PROJECT NARRATIVE
ZONE CHANGE REQUEST AND
OFFICIAL DEVELOPMENT PLAN FOR
DEWEY APARTMENTS

DEWEY APARTMENTS

REVIEW COMMENTS

TITLE HEADING: Rezone from RSF-8 to PR
& Outline Development
Plan

SITE PLAN

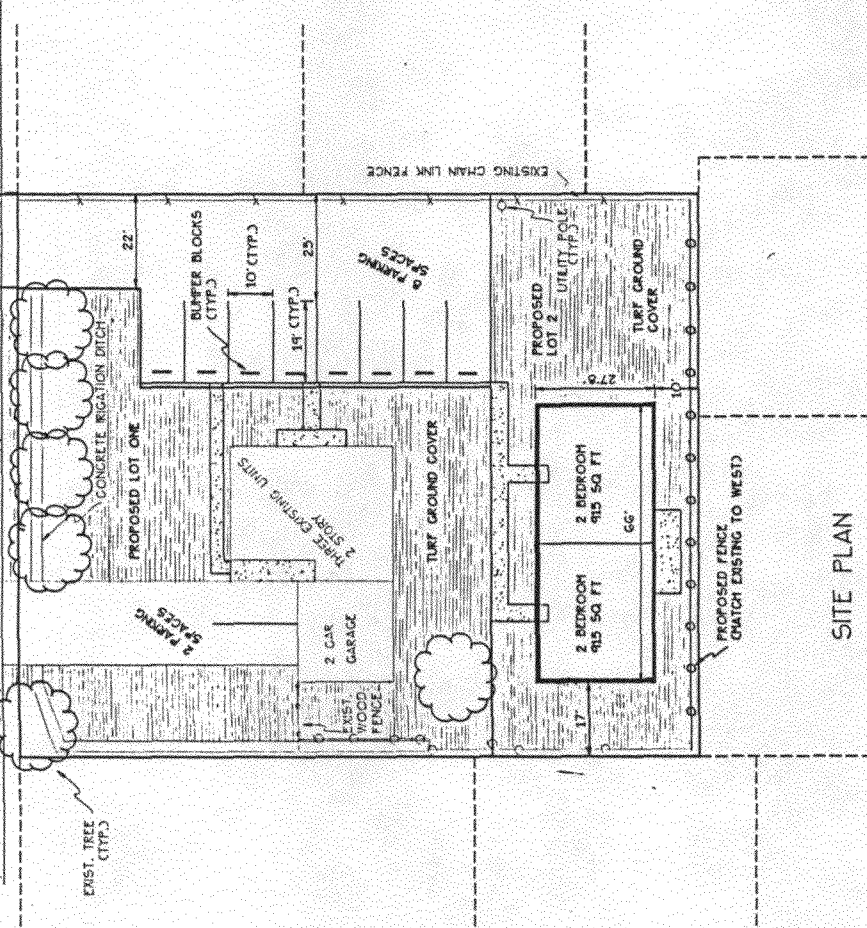
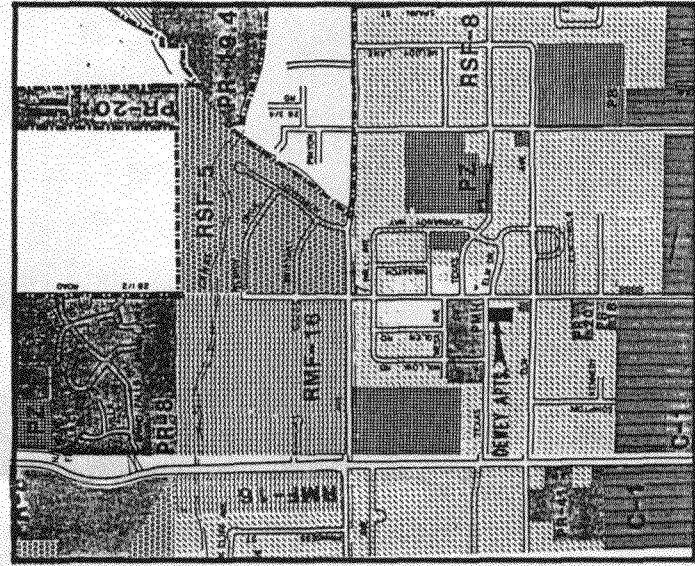
ELECTRIC & GAS: Request that the ingress-egress easement be dedicated also as utility easement.

1. Show proximity of fire hydrants to proposed building location. Additional hydrants may be required due to distance from the street.
2. What are the fire flow requirements?

1. Show proposed location and size of sewer services to line in Texas Avenue.
2. Contact Fruitvale Sanitation for sewer tap fee.

A fire flow survey needs to be conducted to determine the required flows and if additional fire protection is required. Submit a complete set of building plans to include a utility composite of the area (to scale) for our review. This is to include the location of existing fire hydrants.

1. Parking lot stalls should not extend into the required 20' front yard setback.
2. Parking lot should be screened from adjacent property with a privacy fence or landscaping.
3. The proposed 10' rear yard setback is not adequate. All of the multi-family zones in the Code require a minimum of 20'.
4. If approved, the parcel must be platted with the final plan.
5. If approved, open space fees of \$225 per unit would be required for the two additional units.

The requested utility easement will be added to the proposed ingress and egress easement.

1. Fire Hydrants in the proximity of the site include:

LOCATION	DIST. TO PROP. LINE
28 1/2 Rd. and Elm Ave..	250 ft.
28 1/2 Rd. and Mesa Ave..	350
Willow Rd. and Mesa Ave..	325 ft.

1. The exact location and size of the sewer services will be shown on the final plat and plan.

1. The Final Plat and Plan will be modified so that the parking stalls will not extend into the 20 ft. front yard setback.
2. The proposed fencing plan is provided as requested by the adjoining neighbors. However, if the staff would prefer a wood privacy fence, the plan will be modified.
4. The proposed 10 ft. rear yard setback was proposed in order to provide as much open area between the proposed du-plex and the existing tri-plex. The final plan will be modified to incorporate a 20 foot setback.
4. A two lot Final Plat and Plan will be submitted.
5. Open Space fees will be paid prior to the recording of the final plat.
